STATE OF OREGON
WATER WELL REPORT
 (as required by ORS 537.765)

WATER RESOURCES DEPT.
SALEM, OREGON
NIKE CORPORATE HEADQUARTERS

PROPOSED SEALING PROGRAM

Subject: Special Sealing Standards Request
Well Location: SE 1/4, SE 1/4, Sec 5, T 1S, R 1W

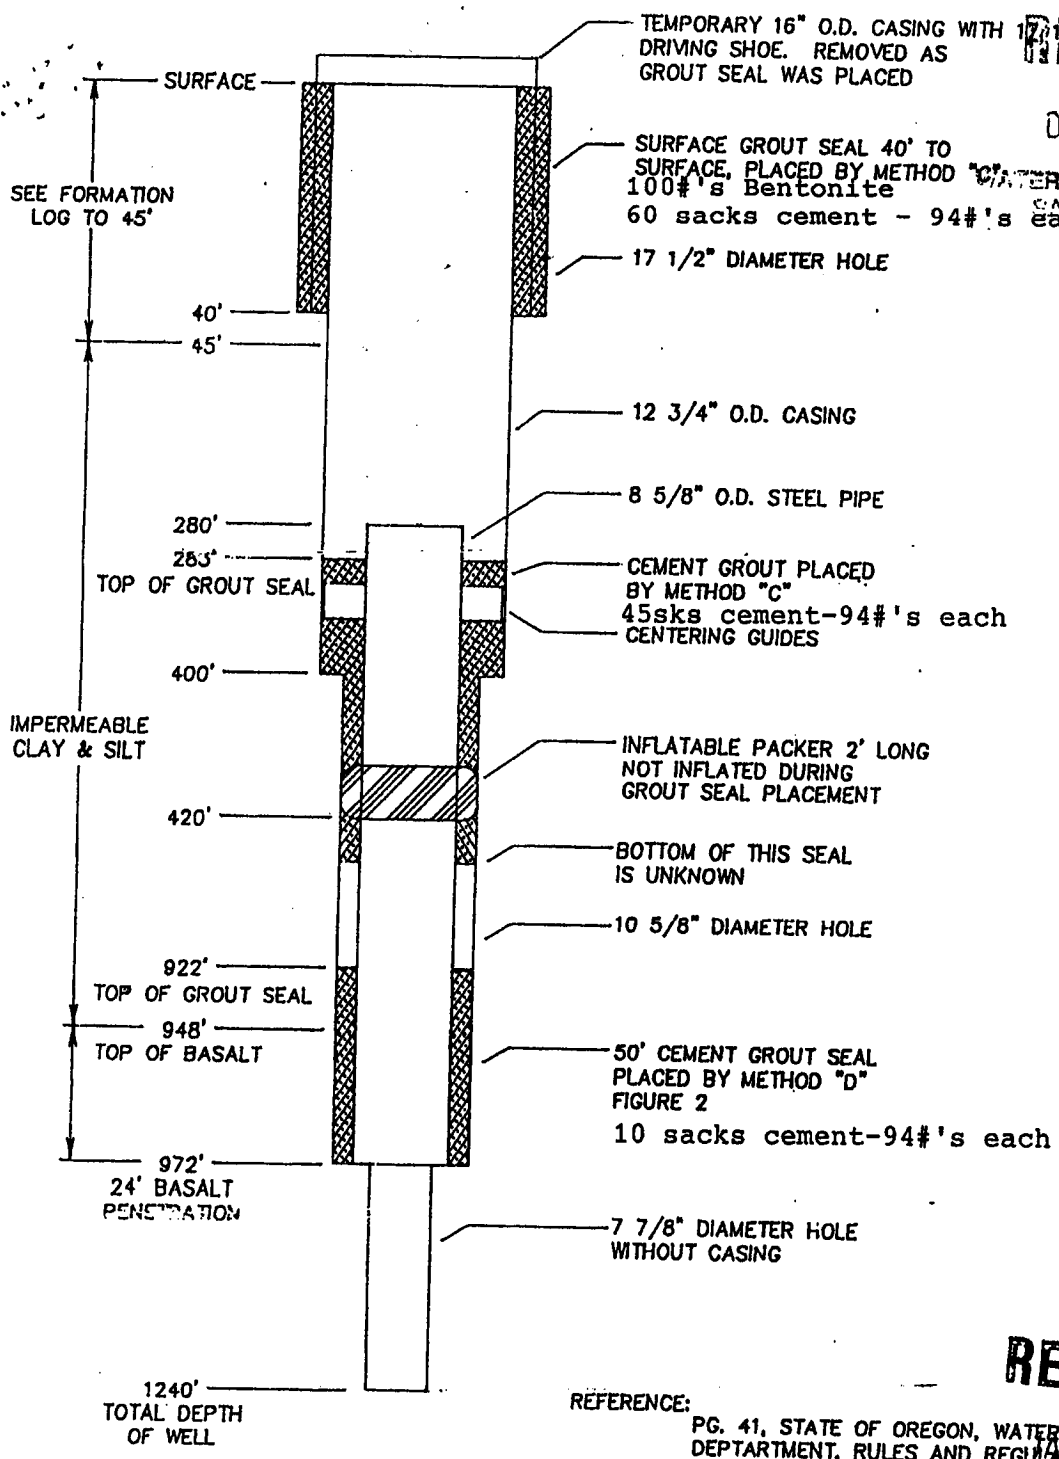
I have reviewed your request for an alternate method of completing the Nike well, located in Sec 5, T 1 S, R 1 W, WM.

I am approving your request as submitted with the exception of requiring a fifty foot neat cement seal between 925' and 975'. As required in the well construction rules, the 8 5/8" casing is to be centered. Centering is especially important in the bottom 50'.

If aquifer testing produces less than 400 gpm, the 8 5/8" casing will extend from 975' to 1' above land surface. The 12" casing will be removed and a neat cement seal will be placed around the outside of the casing 8 5/8" between 975' and 925' and from 420' to land surface.

This method of construction does not conform to the minimum well construction standards. You assured me the proposed construction method will protect the resource. Following construction, if the well is found to be a source of contamination, waste of loss of artesian pressure, you will be required to return to the well site and either repair or abandon the well.

Please contact me prior to placement of the grout seals and prior to cutting any casing. Also contact me if you have questions on this approval.
